DEVELOPMENT REVIEW APPLICATION

2351 Oxford St, Sunset School

Notice of Appeal of Planning Commission Approval

In the Matter of WEST LINN-WILSONVILLE) FILE NOS: CUP-15-03, DR-15-17, and
SCHOOL DISTRICT 3JT's Application for) VAR-15-01/02/03
Conditional Use, Design Review, Director's)
Exception, and Class II Variance Approval to) **SAVE OUR SUNSET PARK'S**
allow construction of a new primary school) **NOTICE OF APPEAL OF PLANNING**
and related facilities in the R-10 zone.) **COMMISSION APPROVAL**

Photo 2 (left). Buttressed roots on Douglas fir (tree number 4446) in park.
Photo 3 (right). Three Douglas fir trees with buttressed roots.

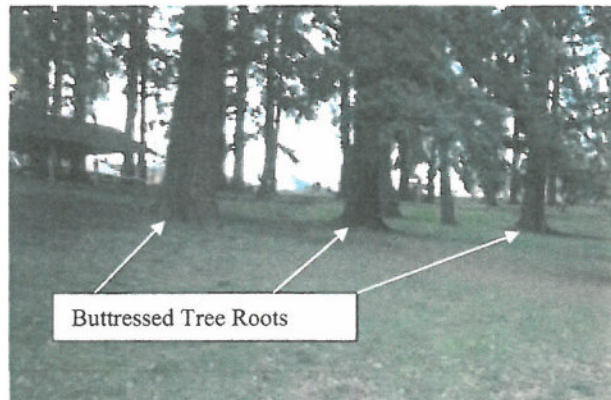
Second, many of the Douglas fir trees in the park have buttressed tree roots, which indicate steep and/or wet slopes. Wet slopes are consistent with the hydric soils shown on Figure 3.8 of the West Linn Surface Water Management Plan, 2006. These buttressed tree roots can be seen in Photo 1 above and Photos 2 and 3 below.

Photo 4. View looking south from the former wading pool towards the playground. The areas of saturated soils can be seen more easily in the playground area where storm water will try to infiltrate.

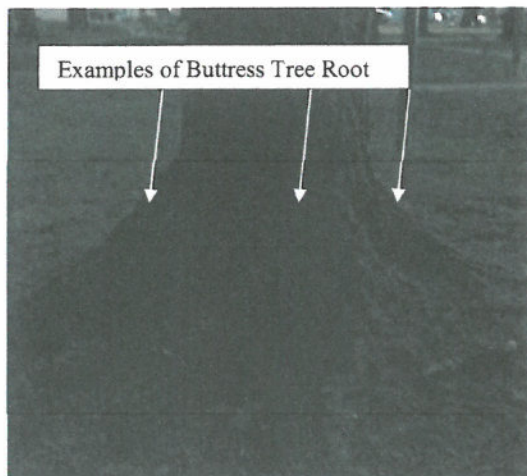
Third, just the filling of the wading pool has changed the hydrology of the site and created areas with saturated soils days after rain. Infiltrating storm water from the pond will increase the amount of saturated soils. Photo 4 shows areas of saturated soils below the filled wading pool. Photo 5 shows a close-up the saturated soils.

Photo 5. View of saturated soils more visible in the playground area. The Douglas fir trees below the playground have buttressed roots.
